Limerick Generating Station, Units 1 and 2  
Renewed Facility Operating License Nos. NPF-39 and NPF-85  
NRC Docket Nos. 50-352 and 50-353

Subject: Application to Revise Technical Specifications to Lower the Minimum  
Standby Liquid Control System Pump Flowrate

**Markup of Proposed Technical Specifications Pages**

FIGURE 3.1.5-1

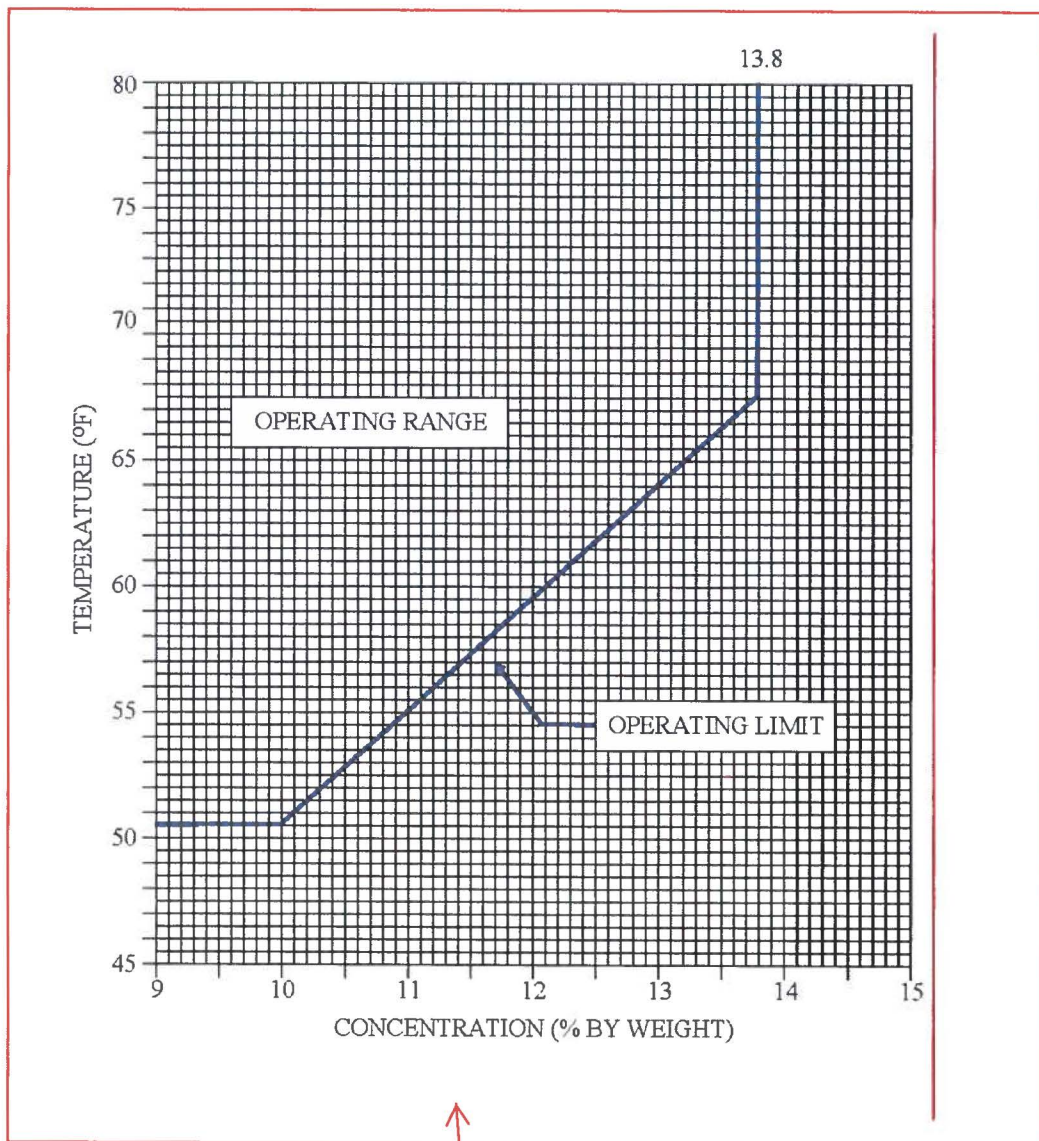
Regarding the Sodium Pentaborate solution operating limit changes, Figure 3.1.5-1 is revised to expand the lower Sodium Pentaborate solution concentration limit value from 10% to 9% by weight while retaining the lower temperature limit of 50.5° F. This will improve the operating flexibility when confirming the SLCS tank contents meet the limits and maintain consistency with UFSAR Figure 9.3-7 (Reference 6.1).

TS Section 3.1.5, Standby Liquid Control System, Figure 3.1.5-1, Sodium Pentaborate Solution Temperature/Concentration Requirements, will be revised to provide a new figure. The new figure extends the minimum operating range limit for the Sodium Pentaborate concentration from 10% to 9% while retaining the lower temperature limit of 50.5° F. This will improve the operating flexibility when confirming the SLCS tank contents meet the TS limits and maintain consistency with UFSAR Figure 9.3-7 (Reference 6.1). This impact of allowing a lower Sodium Pentaborate solution concentration on ATWS analysis and on the pH control of the SP have been determined to be acceptable as discussed above in this section.

Delete this figure  
and replace with  
new figure on next  
page

FIGURE 3.1.5-1

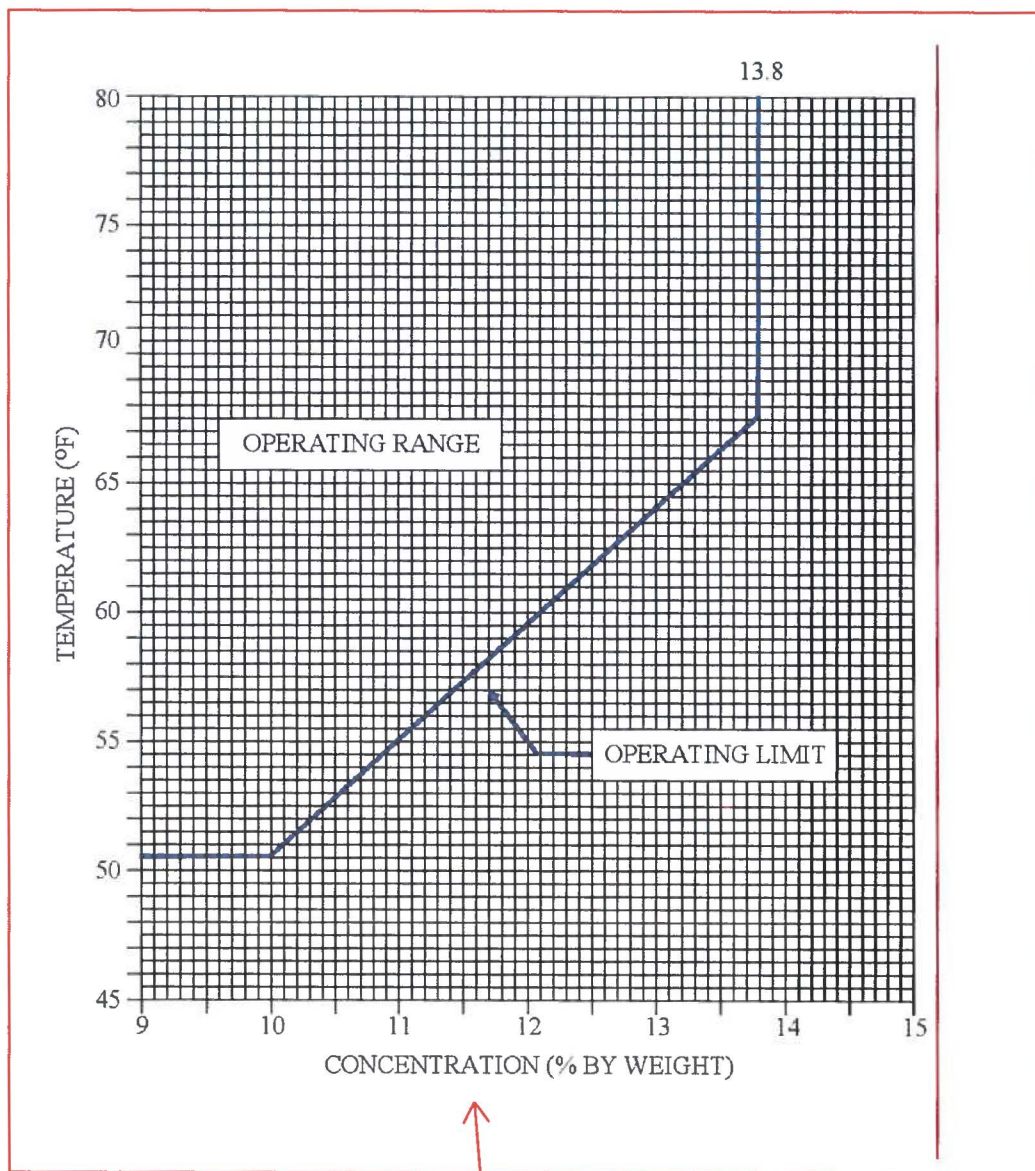
Delete this figure  
and replace with  
new figure on next  
page
